Resistive Imbalance Specification Issues and Limitations

Ken Bennett – Sifos Technologies, Inc.

Resistive Imbalance Ad Hoc

June 10, 2014

PSE Runbalance Requirement VS PSE total resistance (Channel, PD, and System Runbalance unchanged)

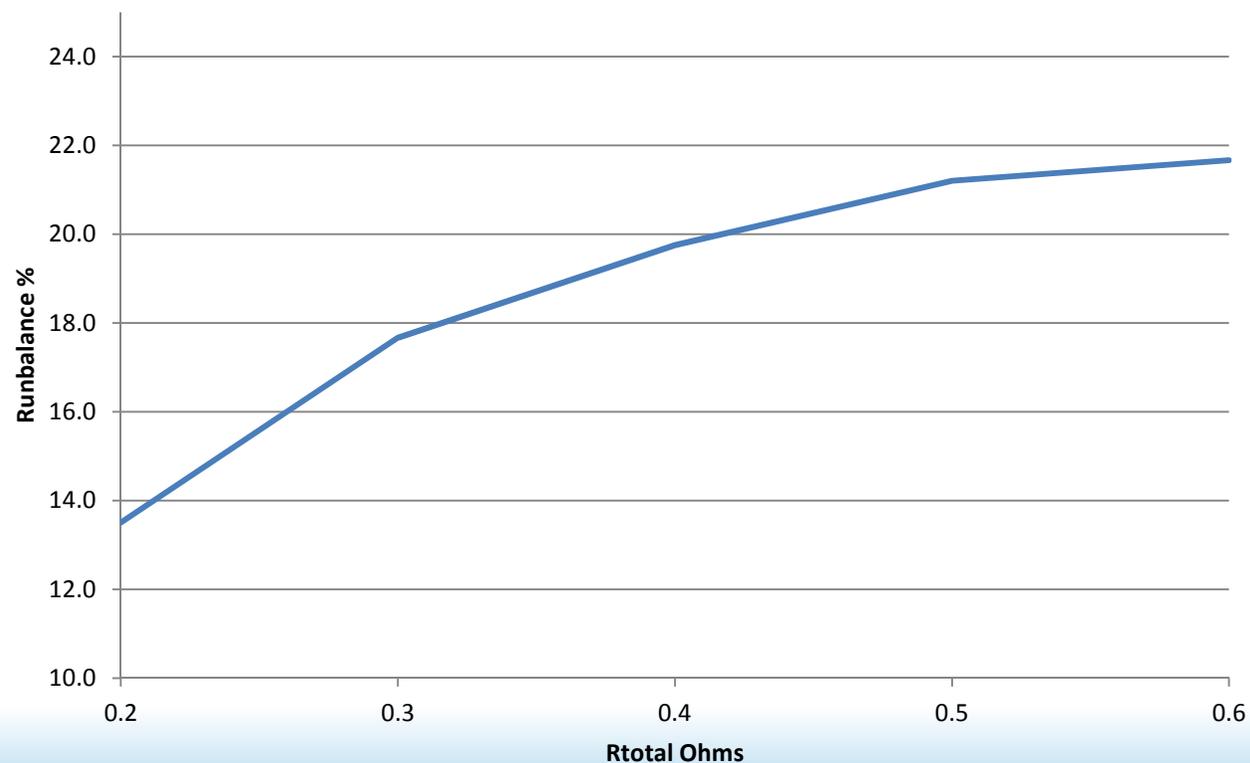
- (Yair: This is unbalance between positive and negative pairs correct?).
- You need to show also between negative and negative
 - positive and positive
 - And use also Rpse in positive rails for complete picture of it.

PD Simulation of Diode vs FET bridge

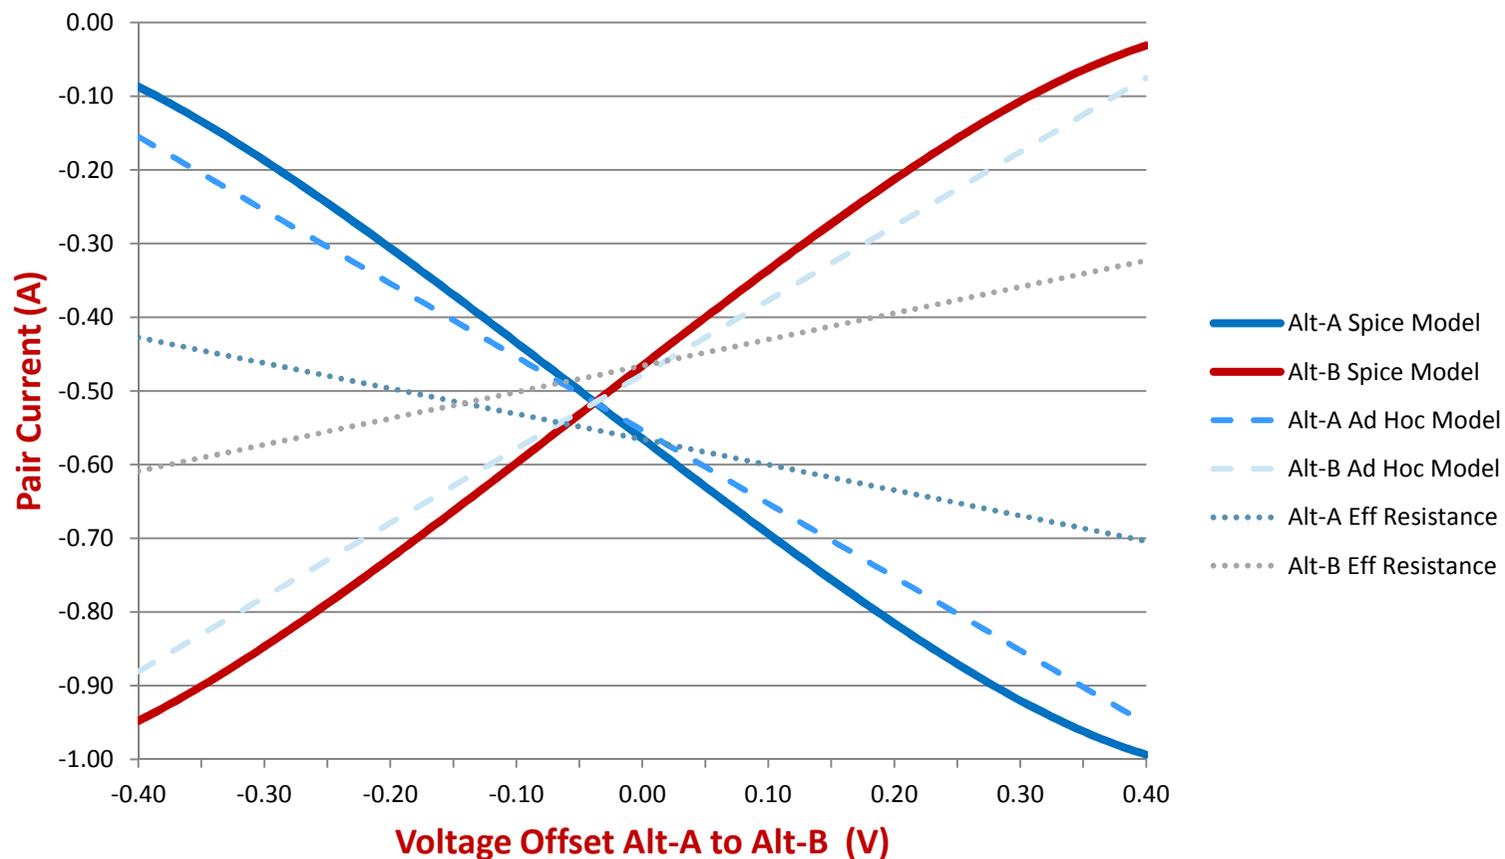
Yair: Same comments as in PSE side.

Yair: do you mean using MOSFETS INSTEAD DIODES? If yes , these numbers are totally incorrect. Using Mosfets are much better for balance. You assume discrete MOSFETS which is wrong.
